# Minutes of 95<sup>th</sup> PCC Meeting

## **EASTERN REGIONAL POWER COMMITTEE**

### **MINUTES OF 95<sup>TH</sup> PROTECTION SUB-COMMITTEE MEETING HELD ON 15.10.2020 AT 10:30 HOURS**

Figure 5: Status of the network of affected area after event 1

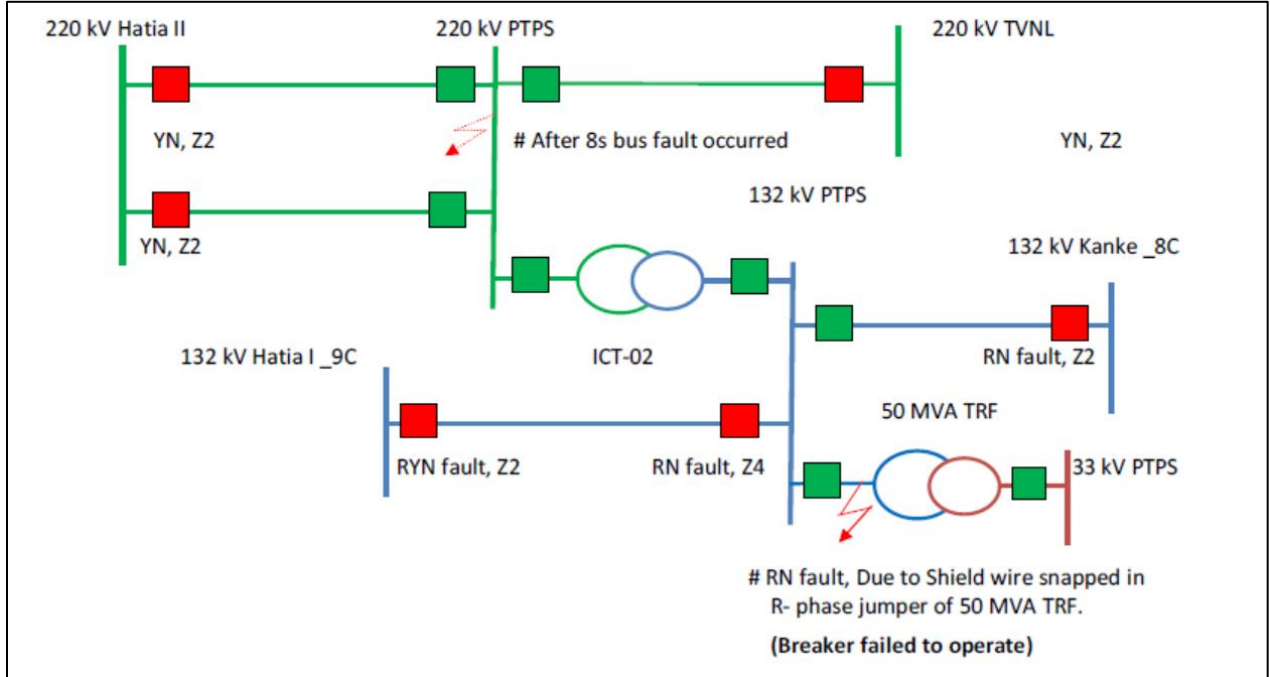
- At 08:45 hrs R phase to earth fault occurred at Patratu S/S due to snapping of the shield wire on 132 kV side R – Phase jumper of 50 MVA, 132/33 kV ICT. Differential & REF (field CT is used for Diff & REF) protection of affected ICT sensed the fault and issued trip command instantly to the breaker. But the breaker failed to operate due to the problem in its mechanism. The air pressure lock mechanism was found in the open condition during the investigation.

kV Hatia Patratu D/C and 220 kV Tenughat Patratu S/C tripped in Zone - 2 protection from Hatia and Tenughat end respectively. As a result, a total power failure occurred at Patratu S/S.

*After detailed deliberation, PCC advised JUSNL to take the following corrective measures to avoid multiple trippings of the transmission elements:*

- LBB protection for 132kV system should be implemented at Patratu S/s.*
- Air pressure alarm annunciation system for 132/ 33 k V ICT circuit breaker should be implemented*
- Operation of circuit breaker of 132/ 33 k V ICT should be checked by giving a trip command from the relay.*
- Reason for non issue of trip command by backup protection of 220/ 132 k V ICT to be analyzed*
- 220 kV Patratu-Hatia – 2 line should not trip Patratu end on Directional Overcurrent protection. Settings related to direction are to be verified.*
- SLDC, Jharkhand should control the TVNL generation depending on the network*

- Healthiness of protection system of 220/132kV and 132/33 kV transformers at Patratu and Hatia to be tested.

Figure 6: Status of the network of affected area after event 2

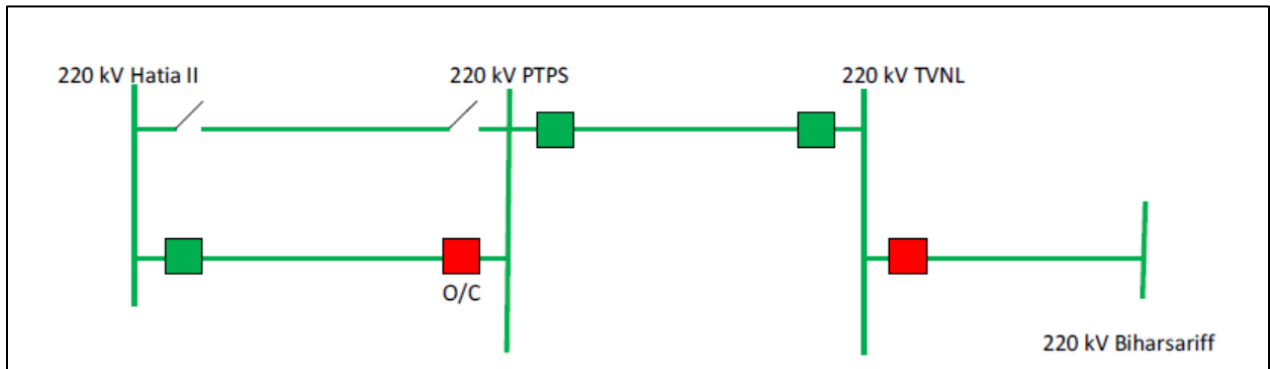
- During event 2, 220 kV Patratu – Hatia – 1 was not in service. At 13:49 hrs 220 KV Tenughat-Biharshariff S/C tripped due to B phase to earth fault at 106 km from Tenughat.

- After the tripping of 220 KV Tenughat-Biharshariff S/C, the whole generation of 220 kV Tenughat generating station was being evacuated through 220 kV Tenughat – Patratu S/C and 220 kV Patratu – Hatia – 2. As a result, Overcurrent protection operated at Hatia end. Current in all three phases at Hatia end for this line was around 600 A. Overcurrent protection setting was Pick up – 100%, TMS - 0.600 CT ratio -600/1. As per transmission planning criteria, the ampacity of 220 kV single zebra conductor is around 550 A for the maximum temperature at 75° C and ambient temperature at 45° C. Hence tripping of power flow through 220 kV Patratu – Hatia – 2 was more than its thermal limit prior to the tripping. **JUSNL may check the directional setting of this line at Hatia end.** As power was flowing towards Hatia, the line should not trip from Hatia end.

*PCC opined that generation of TVNL should be limited to comply with N-1 network criterion to avoid tripping of 220 kV Patratu-Hatia – 2.*
